MICE Spectrometer Solenoid 2B Issues

V.S. Kashikhin, July 19, 2010

The MICE Solenoid 2B review was requested by the FNAL Directorate because of several magnet system failures during tests at the vendor site. This report is based on findings during a vist to WANG NMR (See Appendix), discussions at LBNL, and MICE Notes [1] –[12]. The report is related to the possible failure scenarios and concentrates on the electromagnetic nature of these issues. In general there were two types of failures:

Fig. 1 Magnet 2 burned out HTS lead.

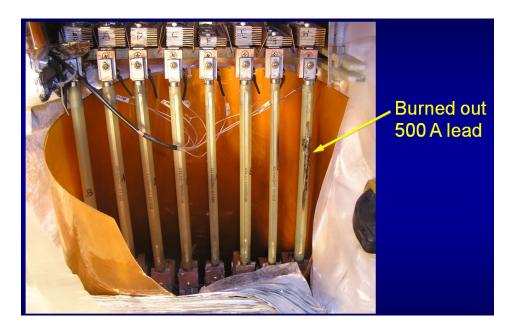
- Burned HTS current lead (See Fig. 1) at 238 A current and 81K leads temperature [11].
- Coil M2 open circuit after the 257 A quench.

Regarding the first item above, after modifications the solenoid 2B was successfully cooled down to 4.5 K, the helium vessel filled with LHe, and HTS leads were operated at reasonable temperature, 50 K. Nevertheless, additional losses during quench could overheat HTS current leads, and busses. These areas should be properly modeled and investigated to avoid potential future HTS lead failures.

Fig. 3 Solenoid electrical circuit schemes: original (left), 2B test (right).

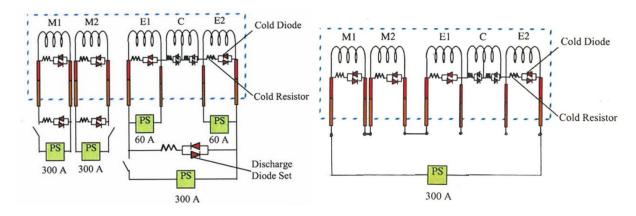
After fabrication the spectrometer solenoid was trained to achieve the specified operational current of 270 A. All 5 coils of the solenoid were connected in series and powered by the 300 A power supply (See Fig. 3). After the quench at 257 A, the M1 coil showed an open circuit. It is possible the following quench scenario occurred:

- The quench started in the central coil, C, with a current decay ~ 5 s (test info).
- Eddy currents are induced in the coil mandrel.
- In all the other coils there is an induced additional current (in addition to the 257 A positive direction current) in an agreement with the Lentz law.
- The decay time of mandrel eddy currents is defined by the value of the power losses, material heating, heat capacity, and density.
- The decay time in the coils that have not quenched will depend on the value of the shunt resistor (20 m Ω).
- There is a "quench back" effect when the heat from the mandrel increases the coil temperatures and transfers them into a normal resistive condition.
- There is a strong coupling between the 5 coils. The coupling is proportional to the self and mutual coil inductances.
- The cold diodes open immediately after the quench.

- Make a full quench analysis covering the test and operating scenarios. The model must include the real solenoid geometry and material properties;
- Modify the test procedure so all coils are not connected in series for training;
- Consider lower risk solenoid training. For example initially train coils M1 and M2. After that E1, E2, CC with coils M1-M2 powered from a separate power supply at the peak current achieved during training for M1-M2. In this case the M1-M2 circuit will have a small current-field margin and will be quenched almost simultaneously with E1-CC-E2.

Fig. 7. Upper and HTS leads configuration.

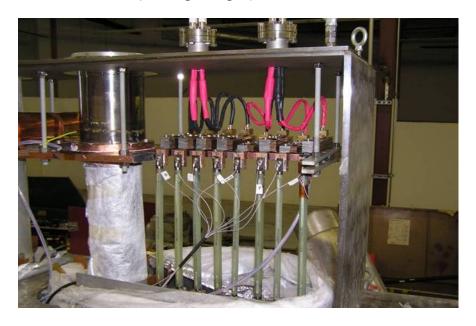
The steady state magnetic field analysis showed that the calculated peak fields are in agreement with the MICE documentation. Nevertheless, it should be noted that manner in which the current leads were installed does not necessarily result in the position of the leads being fully known after cooldown (See. Fig. 7, Fig. 8).

In addition the cold mass axis position was not absolutely fixed during assembly, there is some chance that it could deviate from the outer vacuum vessel axis. Between the two effects, there is some chance the HTS current leads could catch substantial perpendicular field component which will reduce the lead performance (See Fig. 9). This field also could generate circulating currents in the HTS which will additionally heat up these leads during ramping. A more complete analysis and assembly plan should be completed to better understand the position of the leads. If warranted, the addition of a ferromagnetic shield around these current leads will eliminate this effect.

Fig. 10 Flux density on the surface of LHe vessel (R=0.35 m) and in a cold feedthrough areas (R=0.35 m, $Z=^{1.8}$ m).

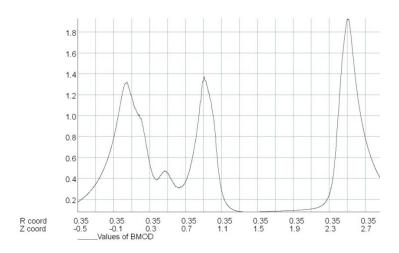
Our calculation showed that the field in the cold feedthrough area is less than 0.1 T (See Fig. 10). In this area there should not be any noticeable Lorentz forces and the field influence on the superconductor performance, even without further stabilization, should not be significant (See Fig. 11).

The superconducting wire on right side of the feedthrough was not additionally stabilized because of limited access to this area during assembly. This area may overheat during a quench.

- If the failure is between the shunt resistor and the feedthrough, Improve the cold feedthrough area and other areas with a single superconductor strand by adding extra copper stabilization;
- If the failure is between the shunt resistor and the coil, the quench protection system should be completely reanalyzed and the modified such that the coils are adequately protected. This could include the introduction of an active quench protection system, or re-optimization of the shunt resistors, for example. Further stabilization of the superconductor strand near the feed through is probably a safe modification in this case as well.

Fig. 12 Coil currents after the quench of the central coil.

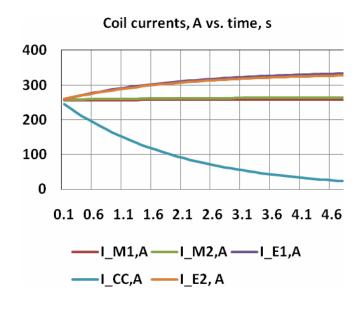
One can see that after the quench the current in the central coil decays from 257 A to I_CC = 20 A after about 5s. But in all the other coils, the currents increase up to: I_M1 = 258 A, I_M2 = 264 A, I_E1 = 334 A, I_E2 = 328 A. Even for the M2 coil which has the lowest inductance, the time constant for the current to decay via the 20 m Ω shunt resistor is 250 s.

Fig. 15 Coil temperature rise during quench because of mandrel heating.

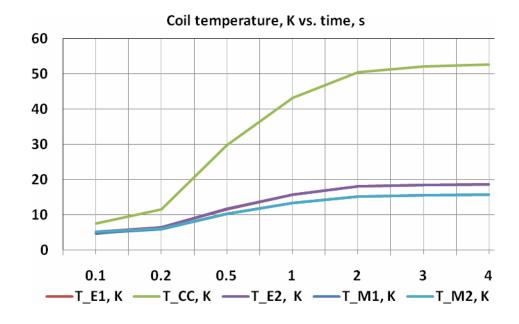
Because the induced current in the mandrel is concentrated under the quenched central coil CC, the central coil is heated to 50 K after 2 s. This is in an addition to any resistive coil heating. The time of the other coil quenches is the sum of the Al mandrel heating time and the heat transfer from mandrel to the coil. Coils E1 and E2 will be quenched after ~ 1.5 s. Coils M1 and

M2 will see "quench back" effect after ~ 2.2 s. If the real thickness of ground insulation is larger than 1 mm, this delay will be even larger due to the additional thermal resistance of the insulation layer. Fig. 15 shows the coil temperatures at different times. It should be noted that power losses in the mandrel during magnet charging with rate of 0.06 A/s is only 0.065 W and does not produce substantial additional heat load. In [5] these losses were estimated at 0.036 W and the AC superconductor hysteresis losses at 1.01 W during the solenoid charge time 4620 s.
